BEFORE THE OREGON PUBLIC UTILITIES COMMISSION

2017 Integrated Resource Plan

Docket LC 68

**SIERRA CLUB COMMENTS
[REDACTED]**

Figure 2. Incremental energy efficiency savings as percentage of sales, historical and IPC forecast

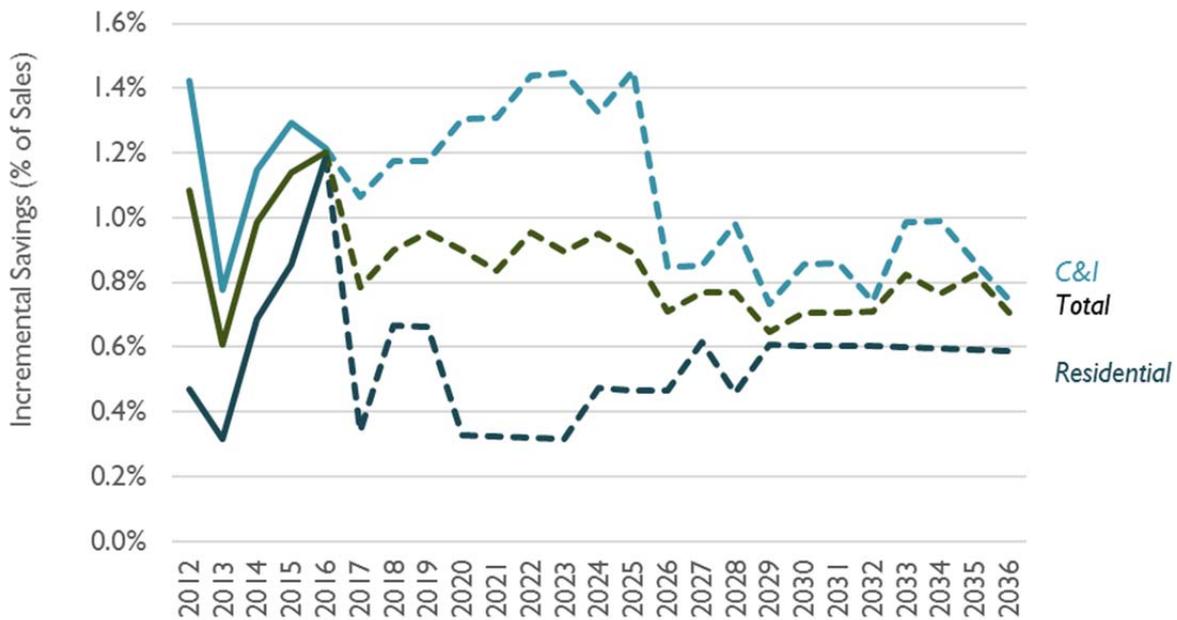
Figure 2 compares IPC’s historical efficiency savings levels to the savings levels included in the IRP. In three of the past five years, including each of the past two, IPC has achieved total incremental savings greater than 1 percent of sales.¹⁹ IPC’s savings levels have increased for each of the past three years, surpassing 1.2 percent of sales in 2016. Nonetheless, IPC forecasts a drastic drop in its efficiency savings, effective immediately. Each of IPC’s scenarios assumes that total savings will plummet by more than 33 percent from 2016 to 2017, and never again reach the levels that IPC has consistently hit over the past several years.²⁰ The drop-off is particularly extreme for residential savings, which are forecasted to decline by about 70 percent in a single year.

Perhaps the forecasted decline in savings would be justified if IPC’s current programs were not cost-effective. But that is clearly not the case. IPC’s latest annual review of its demand-side management programs reports that in 2016, IPC’s energy efficiency portfolio was remarkably cost-effective, with a benefit-cost ratio greater than 2.5 whether viewed from the utility, participant, or total resource perspective.²¹ Only four of IPC’s programs had a benefit-cost ratio

Based on this evidence, we recommend that IPC’s IRP analyses assume future energy efficiency savings that are consistent with its recent savings levels rather than assuming unjustified declines in savings. At a minimum, IPC must evaluate some scenarios in which its energy efficiency savings are consistent with “economic potential” estimates, rather than with “achievable potential” estimates that have consistently proven to be too low.

Figure 3. 2015 incremental savings, AEG projected potentials and actual achieved

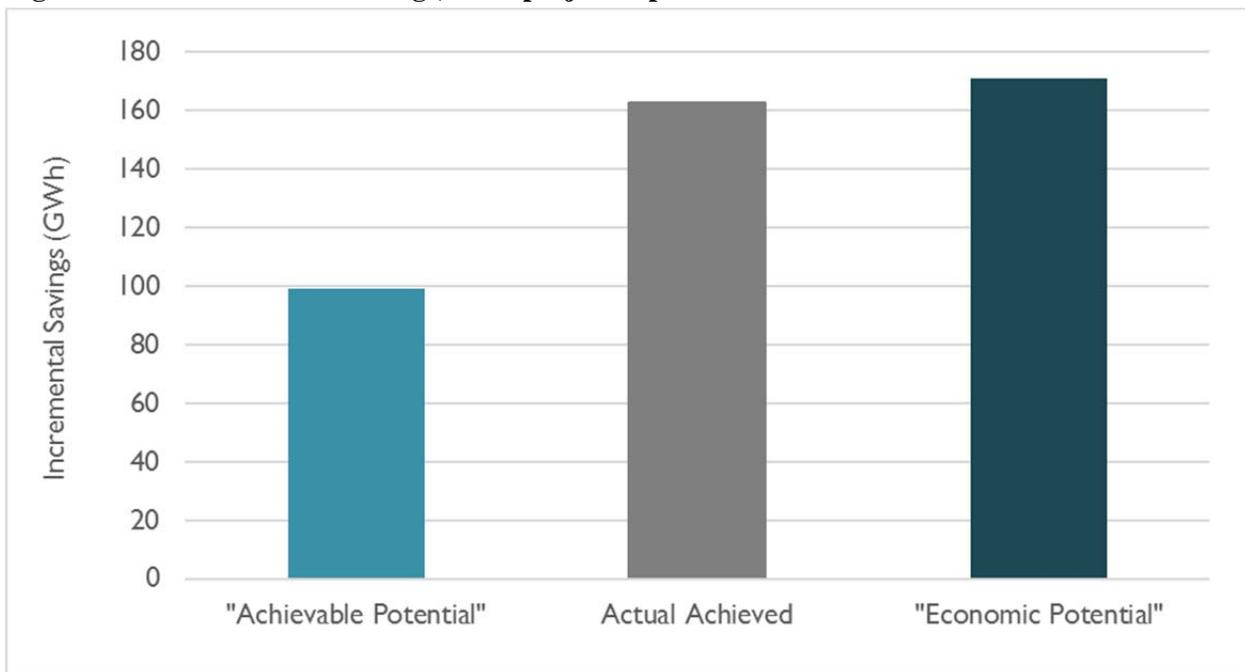
IPC's energy efficiency forecast is ultimately based on a potential study conducted on its behalf by the Applied Energy Group (AEG). As in its previous IRP, IPC relies on AEG's estimate of "achievable potential."²⁸ However, evidence from the past two years indicates that AEG's "achievable potential" estimates tend to greatly understate the cost-effective savings that IPC can actually achieve. The 2015 version of AEG's potential study estimated that IPC's "achievable potential" was limited to 99 GWh in 2015, or 0.7 percent of sales.²⁹ In fact, IPC ended up achieving 163 GWh of savings, or 1.1 percent of sales in 2015, before going on to achieve 171 GWh of savings in 2016.³⁰ Figure 3 shows that these actual achieved savings levels are very similar to the values the 2015 AEG report identified as "economic potential," reflecting "the savings when the most efficient cost-effective measures are taken by all customers."³¹

Figure 6. IPC forecasted market energy prices and Bridger production costs, Portfolio 1

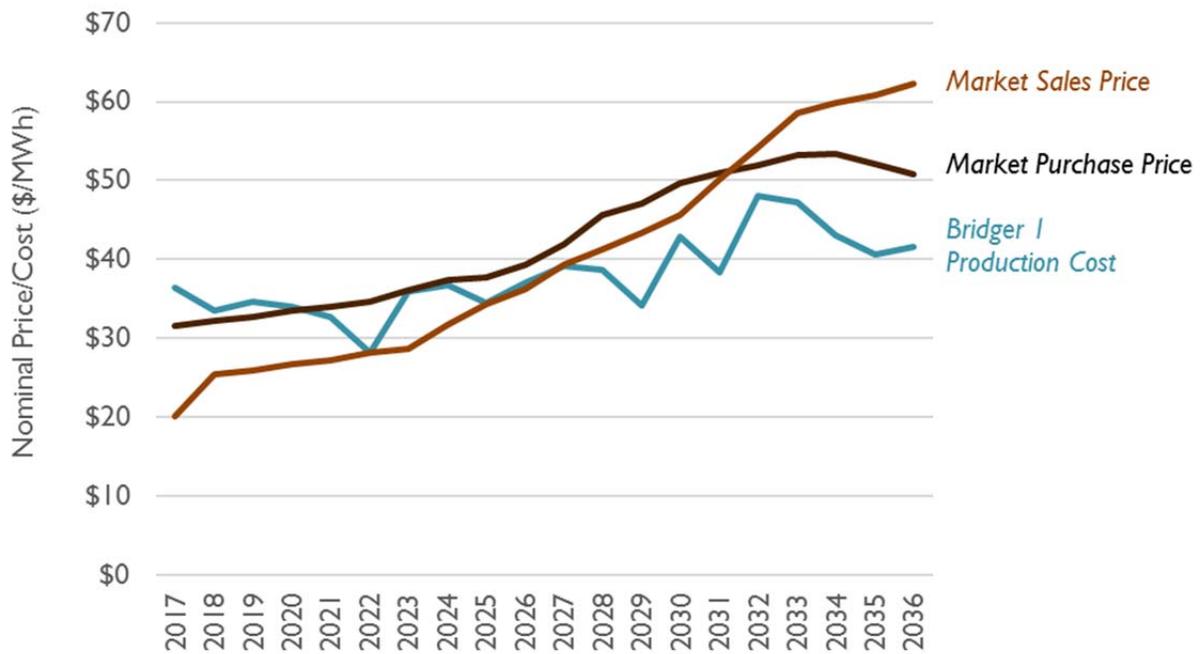
It is the combination of the IRP's assumed decreasing coal prices and increasing market prices, shown in Confidential Figure 5, that makes prolonging the life of Bridger appear economically viable. Figure 6 compares the average production cost of Bridger Unit 1 to the average market

energy sales and purchase prices faced by IPC under Portfolio 1.⁵³ This figure shows that IPC projects that the average production cost of the Bridger units will be higher than the average price at which IPC sells and purchases energy for each of the next four years. This indicates that for those years, the Bridger units will likely not earn enough revenues (or offset enough market purchases) to cover their production costs, to say nothing of their fixed costs.⁵⁴ In other words, Bridger would be losing money in the short term, and banking on low coal prices and higher energy prices over the long term to enable it to become profitable. Without the rapid recovery of market prices, Bridger would be an ongoing economic burden to IPC ratepayers.

Figure 7. Utility-scale solar leveled costs relative to 2017 levels, historical and IPC forecast

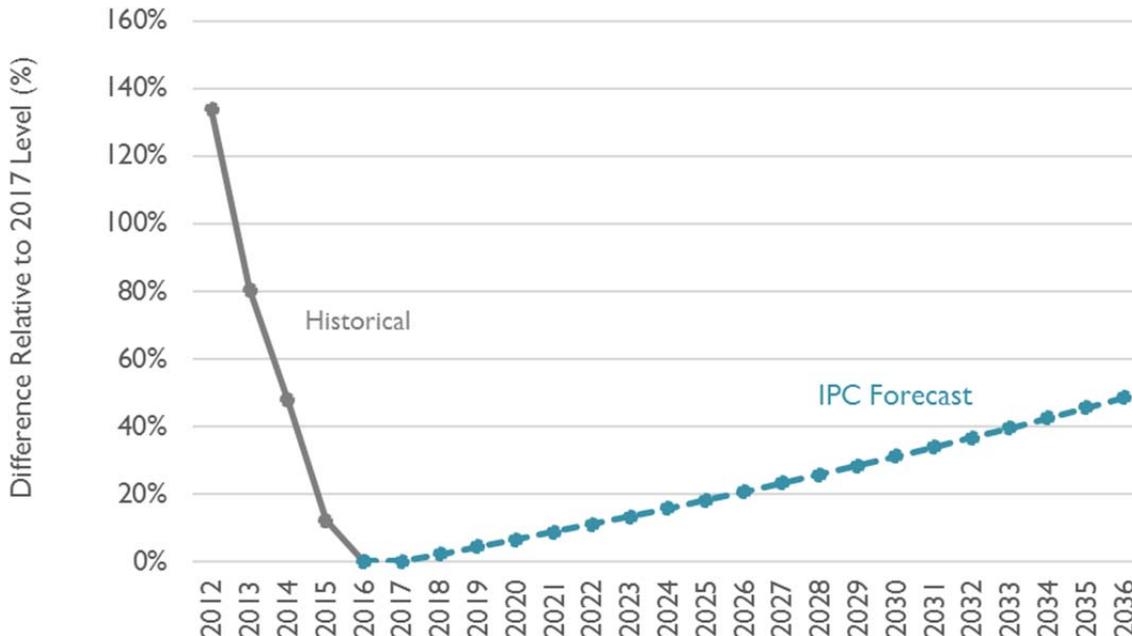
IPC's workpapers show that the Company has assumed that the levelized cost of every new resource technology under consideration will increase at an annual nominal inflation rate of 2.1 percent every year between 2017 and 2036.⁵⁷ This is equivalent to assuming that all resource costs will stay flat in real terms. Such an assumption may be reasonable for certain mature technologies that are no longer undergoing major improvements. However, it is completely unreasonable to assume that the costs of emerging technologies will increase in this way.

The recent dramatic declines in the cost of solar resources demonstrate the fallacy of IPC's cost inflation assumptions. The very Lazard report cited by IPC shows that the unsubsidized levelized cost of utility-scale solar has declined by 85 percent over the past seven years.⁵⁸ While the rate of that decline has diminished somewhat over time, utility-scale solar has nonetheless continued to get cheaper each year. Yet IPC ignores this evidence in assuming that solar costs will transition from their trajectory of decline toward one of steady increase, starting this very year. Figure 7 compares historical and IPC forecasted levelized solar costs, shown in terms of percentage difference from nominal 2017 levels. Under IPC's unjustified assumption of increasing costs, the unsubsidized levelized cost of solar would increase 13 percent between now and 2023, the first year in which solar is procured under any of the IRP portfolios.⁵⁹

Figure 8. Battery storage levelized costs relative to 2017 levels, Lazard and IPC projections

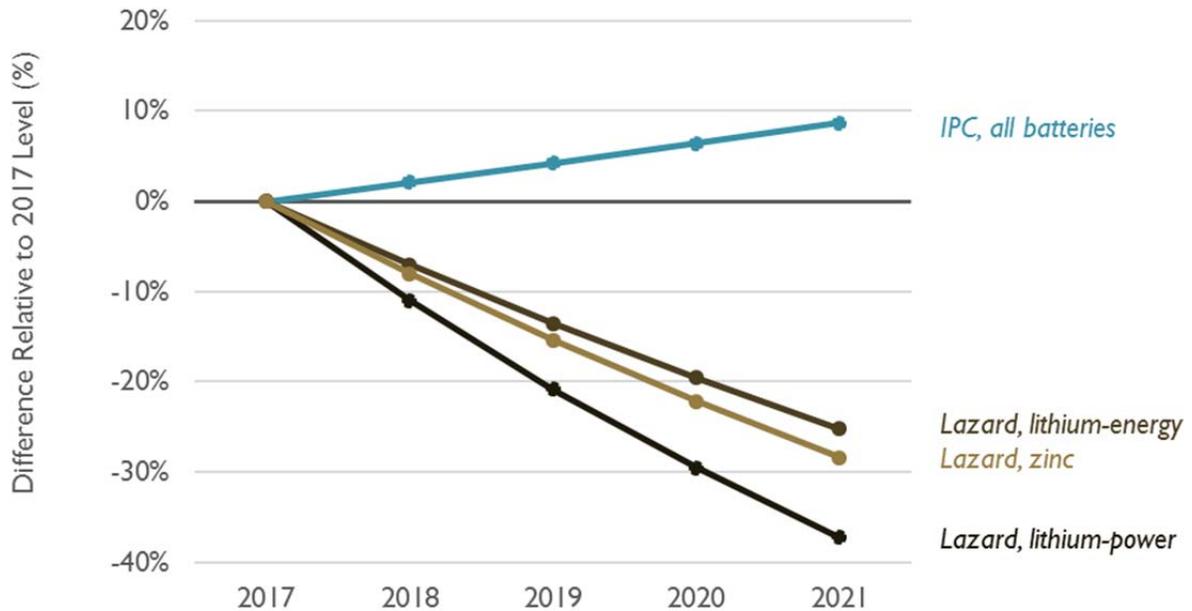
manually selected portfolios appear to include battery storage, a proper IRP analysis would include storage as one selectable option. It would then incorporate reasonable assumptions about the future costs of battery technologies.

Confidential Figure 11. Bridger Unit 1 fixed O&M for Portfolios 1, 4, 10 and 7

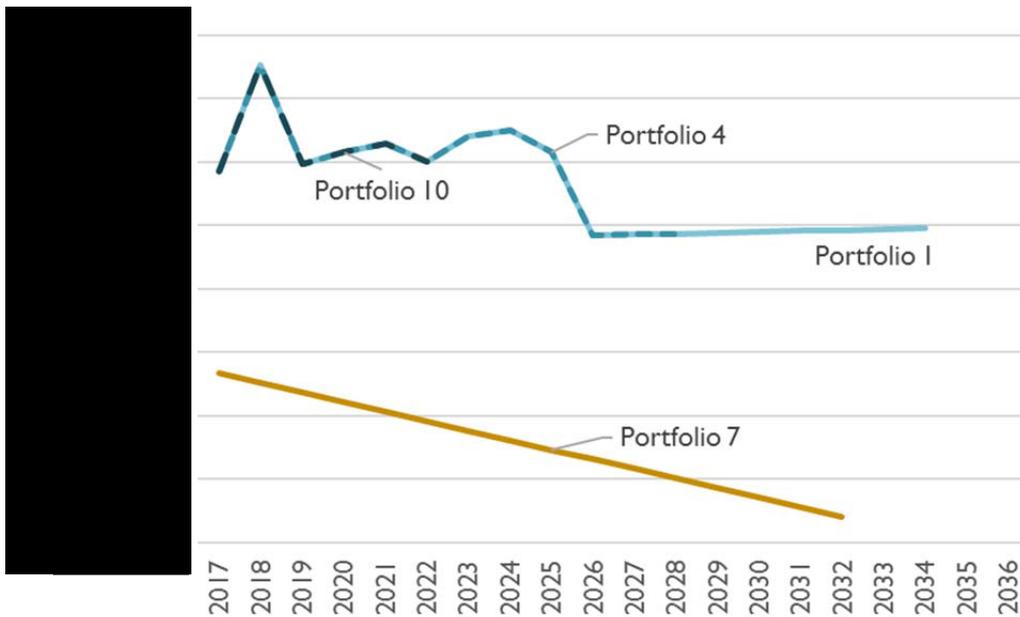
The smaller fixed O&M for Bridger Units 1 & 2 in Portfolio 7 is almost certainly an error, as shown in Confidential Figure 11, below. The substantially smaller fixed costs in Portfolio 7 are inconsistent with all other scenarios modeled, and lower than PacifiCorp projections. It is clear that IPC expects the fixed O&M costs of each Bridger unit to remain the same across all Bridger retirement scenarios for all years in which that unit continues to operate. It is unclear how the Portfolio 7 fixed O&M error came about, but it appears to be a transcription error. While we have determined that this error likely did not impact Portfolio selection, it absolutely impacts the valuation of the Bridger units. Overall, the erroneous fixed O&M costs of Portfolio 7 appear to reduce the forward-looking costs of Bridger Units 1 and 2 by over [REDACTED] NPV. In the sections below, we describe our corrections for this error.

Confidential Figure 12. Value of Bridger Unit 1 under Portfolio 7, as modeled and with various corrections

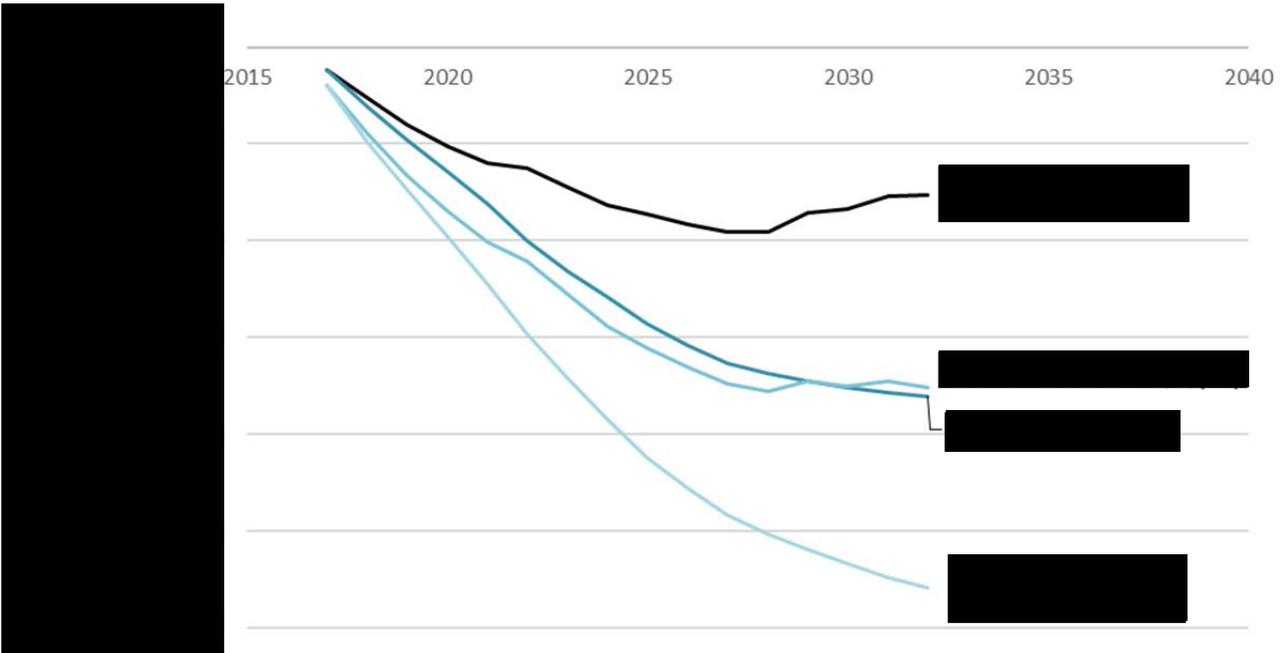
Confidential Figure 12, below, shows the cumulative present worth (CPW) of Bridger Unit 1 as modeled by IPC in “preferred” Portfolio 7 relative to the highest possible cost of energy modeled by IPC. The black line (“IPC Base”) represents the accumulating value (or loss, negative) of Bridger Unit 1 through 2032. The steady drop in the black line through 2028 is indicative of ongoing losses relative to the market. The slight uptick near the end represents a small improvement relative to market in the last years of Bridger’s life. Overall, IPC would estimate a market value for Bridger Unit 1 of about [REDACTED] (NPV, 2016\$) or [REDACTED]/kW. Correcting Bridger’s fixed O&M values to be consistent with all other portfolios results in the lighter blue line marked “Corrected FOM,” and a net liability of [REDACTED].

Confidential Figure 13. Value of Bridger Unit 2 under Portfolio 7, as modeled and with various corrections

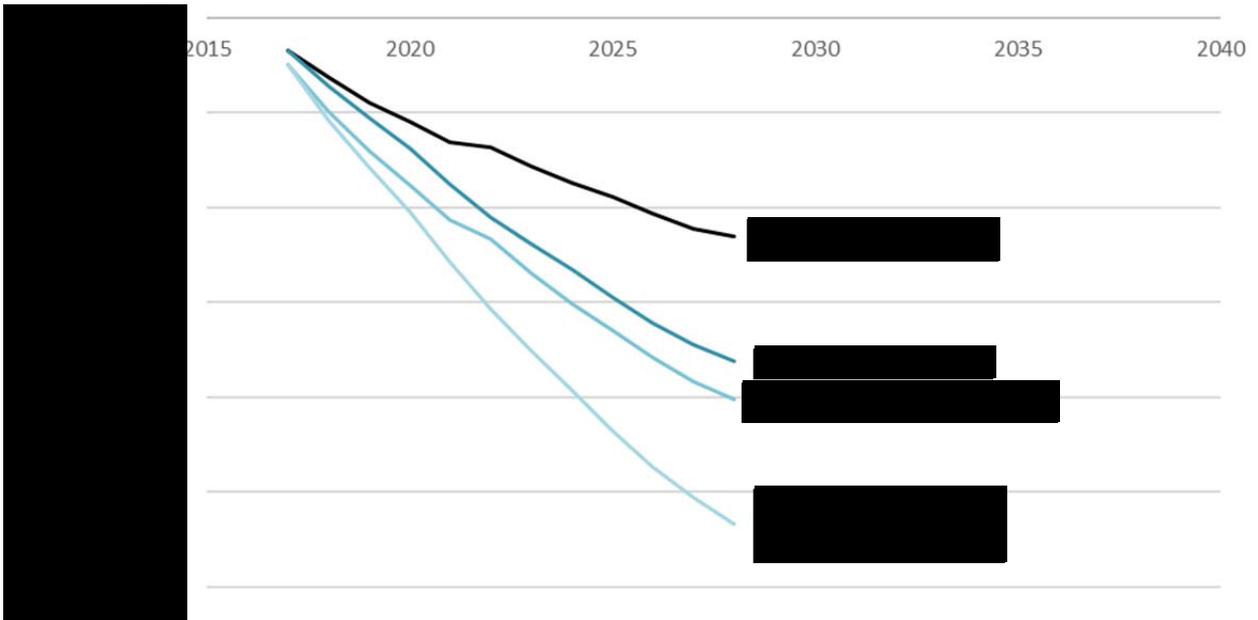
We demonstrated in Section 6.2 that IPC predicts coal prices will drop in real terms from 2017 through 2034, a prediction completely antithetical to observed trends at Jim Bridger over the past decade. In addition, IPC estimated that variable O&M costs at Bridger will drop by [REDACTED] from 2017 to 2022 (from [REDACTED] to [REDACTED]), an assumption that is inconsistent with the operations of coal plants throughout the United States. Simply holding the cost of coal and variable O&M costs steady at 2017 levels (plus inflation) has a dramatic impact on the viability of Bridger Unit 1 in this same scenario. Accounting for both the corrected fixed O&M and flattened fuel and variable O&M costs, Bridger Unit 1 emerges as a [REDACTED] liability through 2032, losing value each and every year. The story at Bridger Unit 2 is no different, as shown in Confidential Figure 13, below.

While we believe these fuel and variable O&M corrections to be valid, we do not rely on those adjustments for our basic point. The fixed O&M schedule under Portfolio 7 is clearly an error. Once this schedule is made consistent with fixed O&M costs in Portfolio 1, the IRP results are much clearer—and far more intuitive. Jim Bridger loses money each and every year that it is online—irrespective of whether it has an SCR obligation or not.

Confidential Figure 14. Value of Bridger Unit 1 under various portfolios, with correction to fixed O&M in Portfolio 7

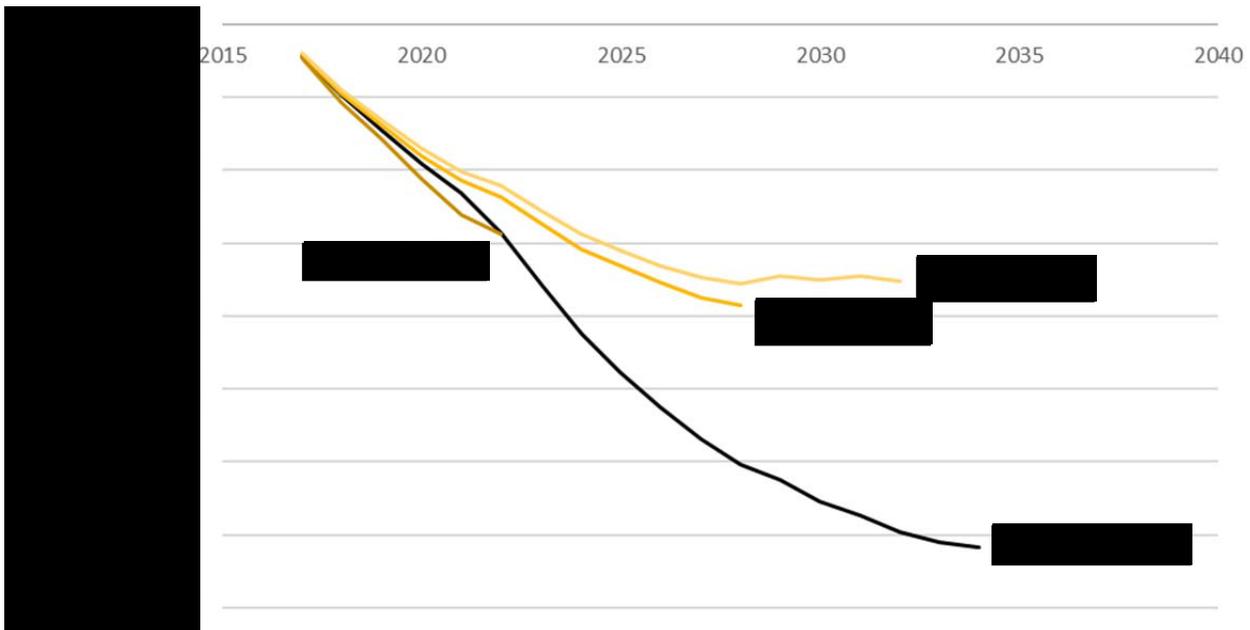
Confidential Figure 14, below, shows the value streams of Bridger Unit 1 under Portfolios 1, 4, 7, and 10—the various retirement options in which B2H is constructed. The Portfolio 1 results indicate that if, in fact, Bridger Unit 1 were required to obtain an SCR, the unit would ultimately cost ratepayers more than [REDACTED] above market energy procurement costs (conservatively). However, the three yellow lines are yet more useful. The close trajectories of Portfolios 10 (2022), 4 (2028) and 7 (2032) show that Bridger will continue to cost ratepayers—and the longer the units remain online, the deeper the obligations become. This means that solutions not modeled by IPC—including a 2018 or 2020 retirement or disentanglement from Bridger—would have resulted in substantial savings relative to the potential costs still yet to be incurred.

These results show that Portfolio 7 is **not** the least-cost or least-risk resource plan available to IPC, and of the portfolios modeled by IPC, Portfolio 10 should result in the least cost to consumers.

Confidential Figure 15. Value of Bridger Unit 2 under various portfolios, with correction to fixed O&M in Portfolio 7

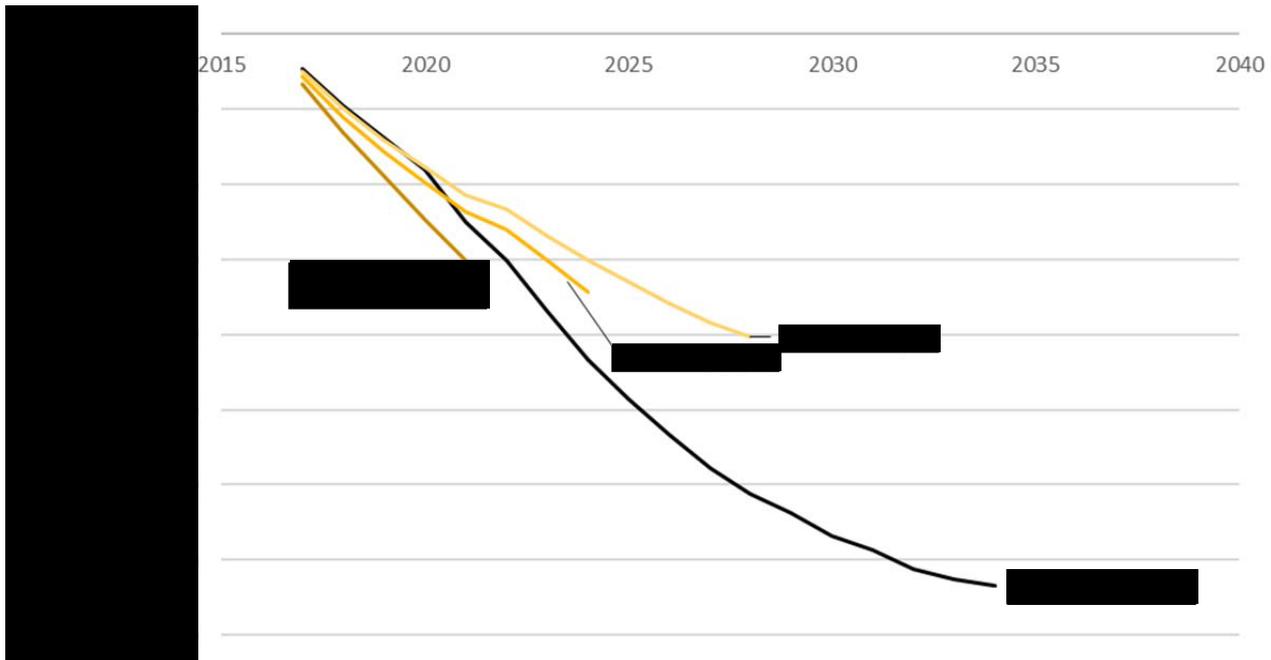
Confidential Figure 15 shows nearly identical results for Bridger Unit 2.
